Tangy IV Wind Farm Section 36C Variation

Technical Appendix 3.2: Scoping Opinion

**Scoping Opinion on behalf of Scottish Ministers under the
Electricity Works (Environmental Impact Assessment) (Scotland)
Regulations 2017**

**Tangy IV Wind Farm - Varied Development
SSE Renewables Limited**

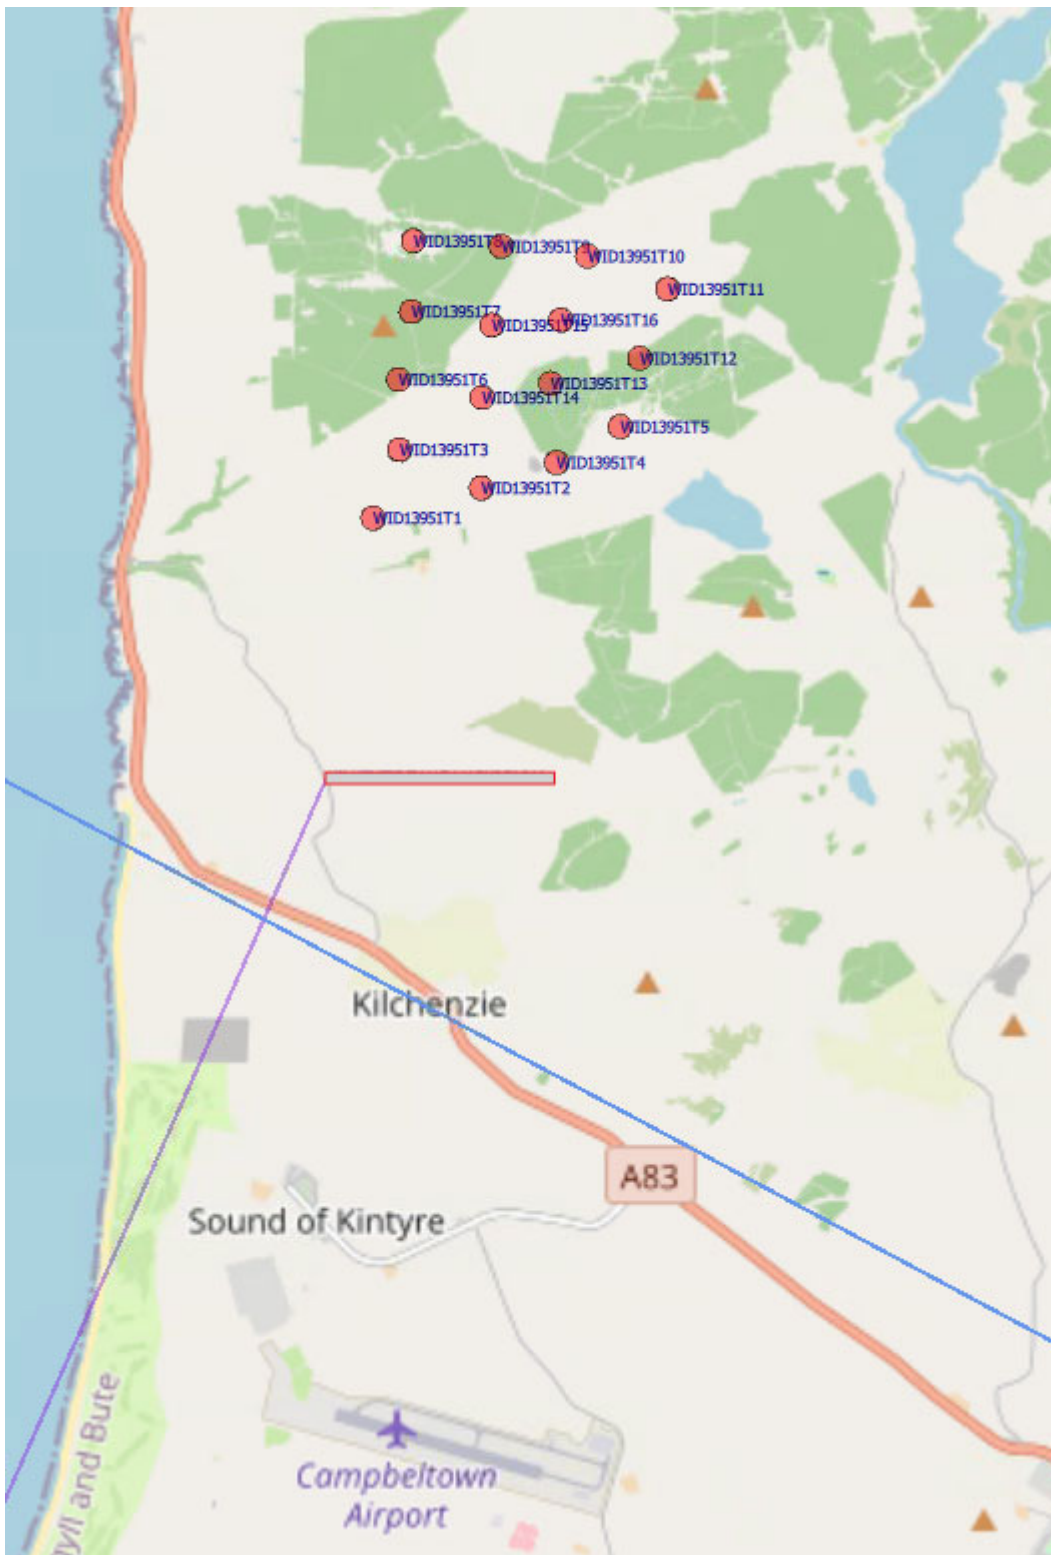
The conclusion is that this proposal should not cause interference to BT's current and presently planned radio network. Please note the site boundary on the attached shown below this may cross one of radio links demonstrated by a blue line. If there are any new structures at height that will cross our link path, please confirm its co-ordinates and dimensions and we will assess for you. If this does not, then there is no need to reply this is approved.

BT requires 100m minimum clearance from any structure at height to the radio link path. It should be noted that this decision is for the date of its issue as the use of the spectrum is dynamic and can change on an ongoing basis. Therefore, please reconsult us if there are any further changes during the planning process with heights and locations of any structures, and its finalisation, as we may have new links assigned by Ofcom over its duration.
